## **Submission at the invitation of An Bord Pleanála on ABP-315173-22**

**Planning Authority Reference Number:** 22331

**Re:** Construction of a rockfill and earthen reinforcement buttress to sections of the extant embankment wall of the Tailings Storage Facility. An Environmental Report and a Natura Impact Statement (NIS) were received with this application.

**Development Address:** Randalstown, Simonstown and Sillogue, Navan, Co. Meath.

*Figure 1 detailing various methods of building a Tailings Dam<sup>1</sup>*

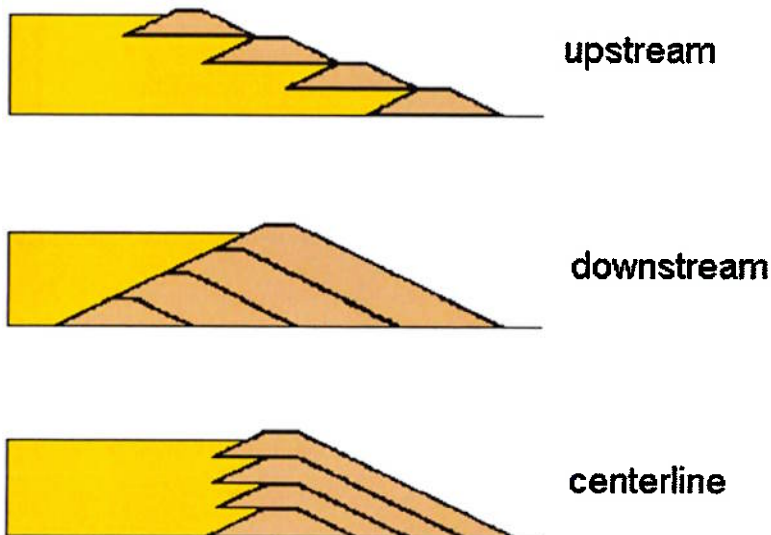
The Tailing Dam construction of sections 1 to 5 are of the upstream construction method. This involves building the next lift of the dam wall on the hydraulically placed material. The upstream methods uses least materials for the dam wall but is the least stable.

The proposal is to carry out remedial works to dam of upstream construction and to use it to impound water keeping the slurry deposited in a wet state indefinitely.

Figure 2 above shows the 2mm HDPE membrane detailed in the planning application for the stage 6 extension NA160408 Meath CoCo<sup>4</sup>

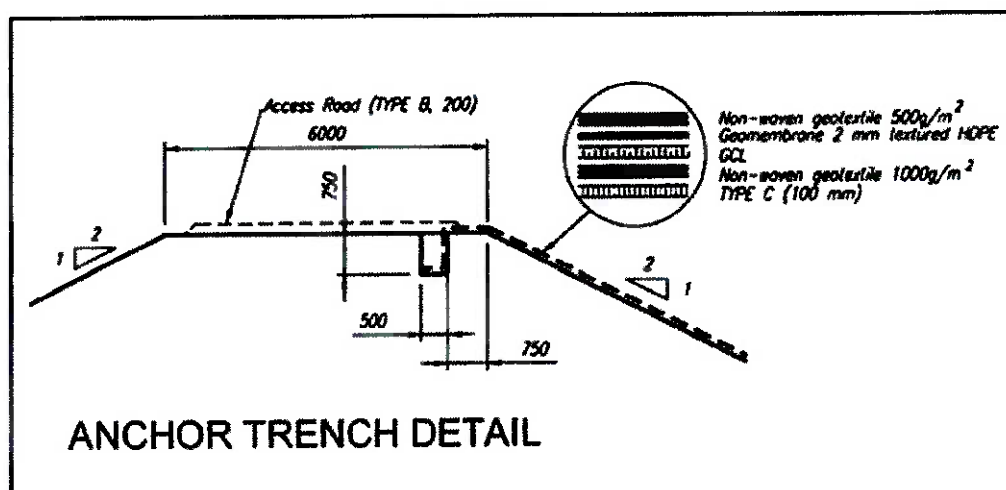
ABP should note that the newest section of the Tailings Dam Section 6 has a modern liner membrane in the dam wall construction, a method that is far superior than the method used in the tailings dam wall section 1 to 5.

The tailings dam design for section 6 has a 2mm liner which offers stability advantages over the upstream design build on mine tailings of unknown particle size and with unknown geotechnical characteristics.

Figure 8 ICOLD Bulletin 194 Committee L – Tailings Dams and Waste Lagoons 2023<sup>10</sup>

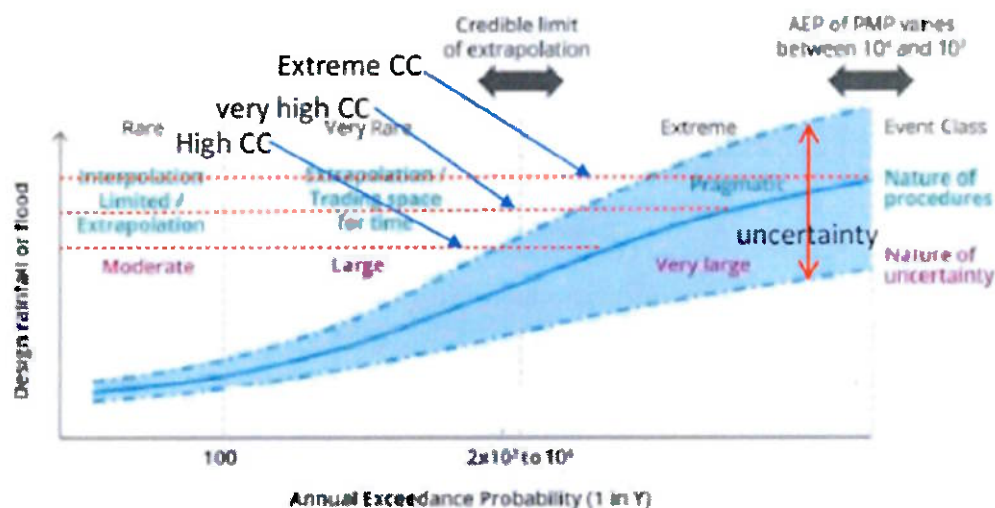
Obviously the 1 in 1000 year risk assessment is grossly inadequate
